Re: 95 Chadwick Street – Exterior Alterations and Addition

PUBLIC HEARING
95 CHADWICK STREET

RE: June 20, 2001 – Public Hearing – HP Report #13-01

Application For: Certificate of Appropriateness – Exterior Alterations

3 Chadwick Street Elevation - West: Sceme 'A'
1/4" = 1'-0"

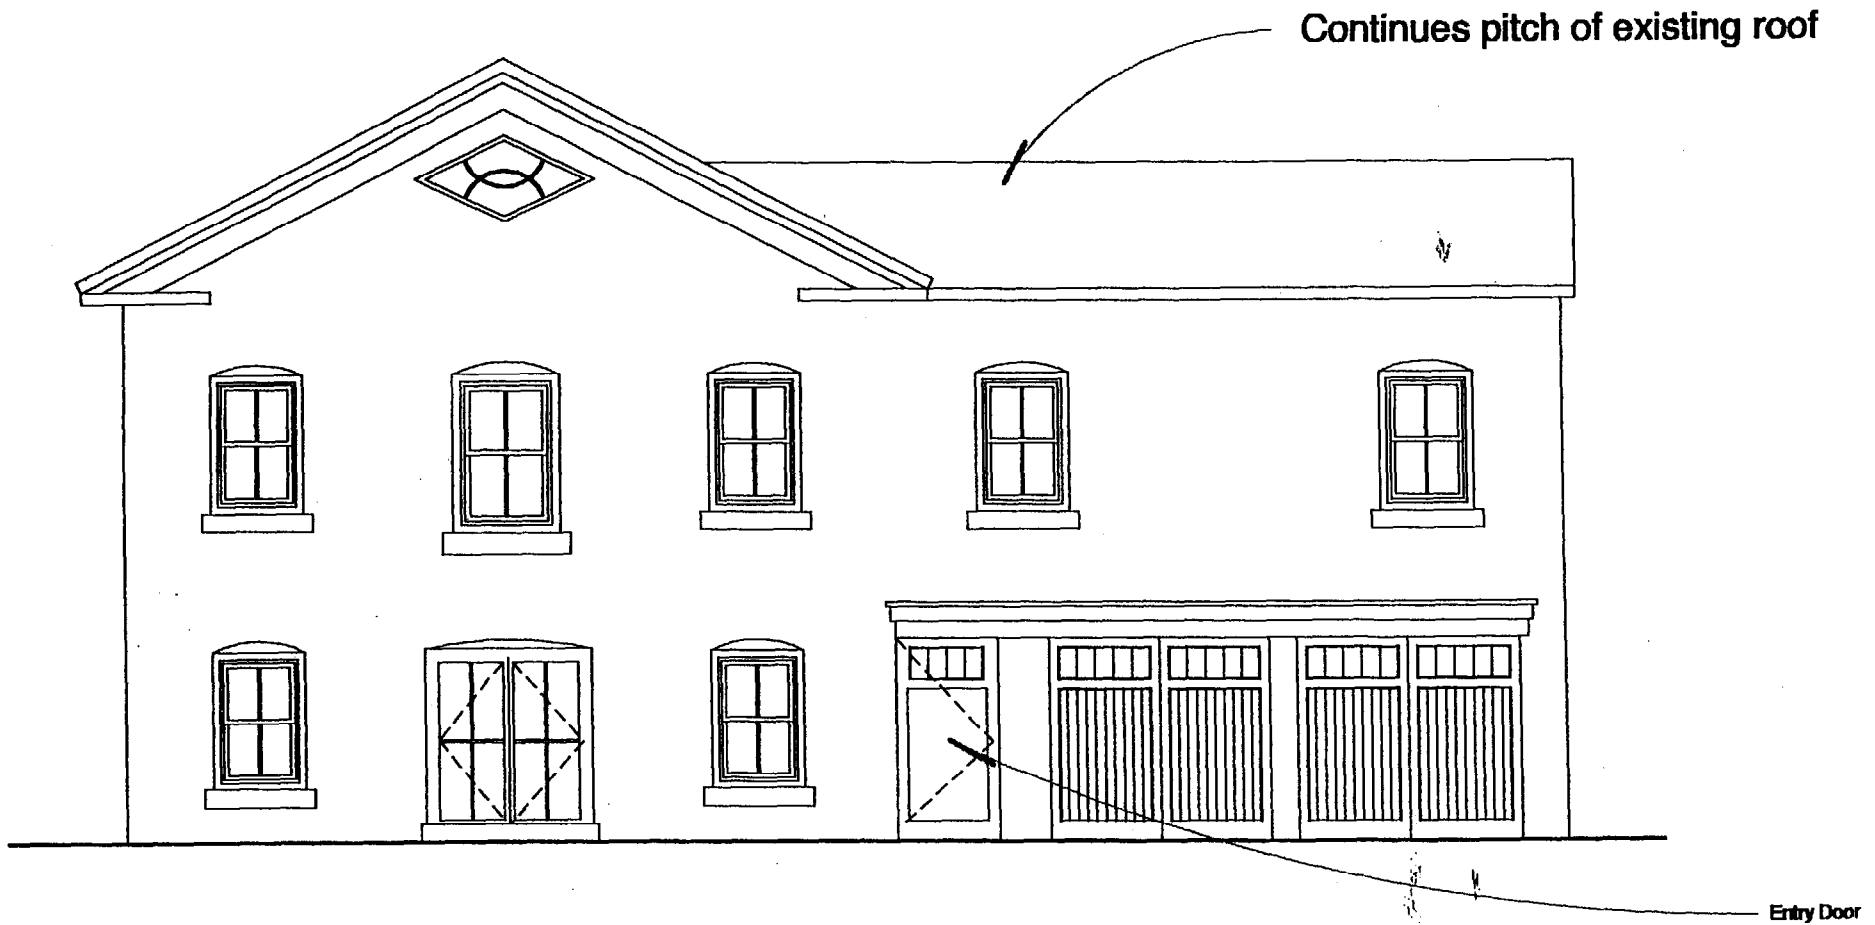
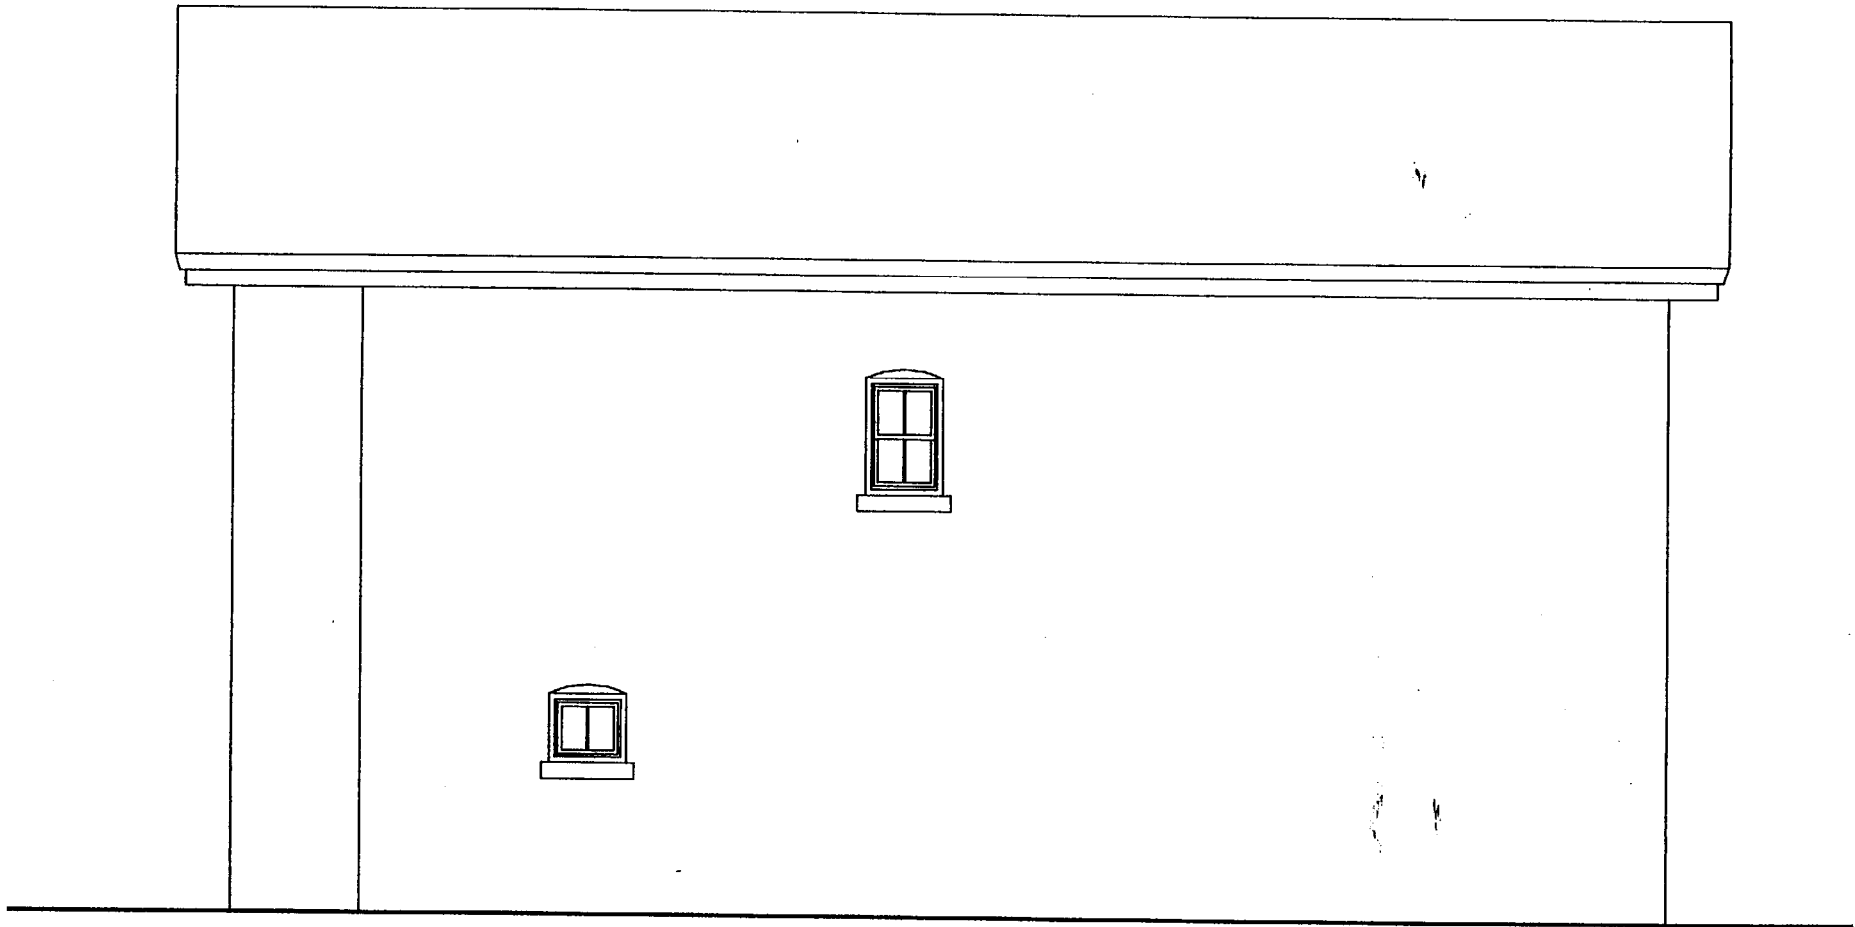
- The wood infill panels between the garage doors and entrance door are to be finished at the base with a piece of wood trim;
- The new entrance door is to be constructed according to the "Scheme A" option;
- The finish color of the replacement window sash is to be reviewed by staff, with the recommendation that it be compatible with the tones that are traditional to the Italianate Style.

Instead of replacing the picture window in the original front entrance on the west façade with a pair of sash windows, as originally proposed, the applicant has followed the Committee's suggestion by proposing a pair of wood French doors manufactured by Kolbe & Kolbe, each featuring four large window panes.

The interior reconfiguration of the carriage house will result in a larger garage with the capacity for two cars, and shift the entrance doorway slightly to the north. The applicant has agreed to follow the Committee's suggestion to bring the garage and entry wall out flush with the rest of the west façade. The wood brackets currently framing the opening are to be removed, but the structural beam faced in wood will remain, with an added cornice trim to reflect the detailing found elsewhere on the carriage house. The applicant is proposing to replace the existing single garage door with a pair of overhead garage doors manufactured by Designer Doors. These wood doors, featuring large panels of vertical boards and five-light "transom" windows, create the appearance of two sets of paired swinging or sliding carriage doors. The new entry is proposed

to match the garage doors, featuring a transom-like window with a single panel beneath. Two options are proposed for the panel—the vertical board treatment (Scheme A) or a flat surface (Scheme B). (See Attachment 3 for elevation drawings.)

The Committee may wish to clarify the dimensions of the rails, stiles, and muntin widths of the proposed French doors on the west façade to ensure that they are in proportion to the size of the opening and compatible with the proposed window replacements on the rest of the façade.

Staff suggests that it is important for the proposed garage doors to “read” as single, solid elements as much as possible. Committee members may want to request details on the operation of the overhead doors and clarify whether they will swing upwards as a single door or “roll” up in horizontal sections. If the doors operate in sections, the Committee may wish to clarify the number of sections and how the seams are treated. In addition, the Committee may also want to ascertain the detailing of the vertical board panels, as the door specifications list a number of options, including v-groove and beaded treatments.

1 Proposed First Floor Plan

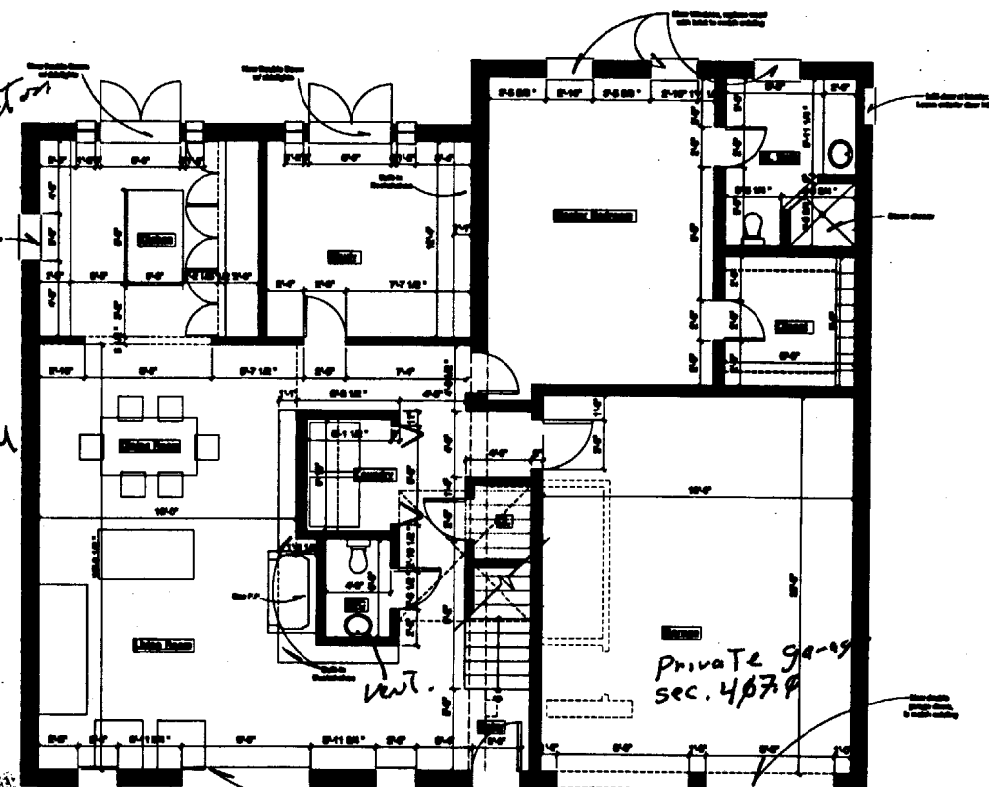
Smoke detector
Sec. 920.3.2

Sleeping porch
window - Sec. 1010.4
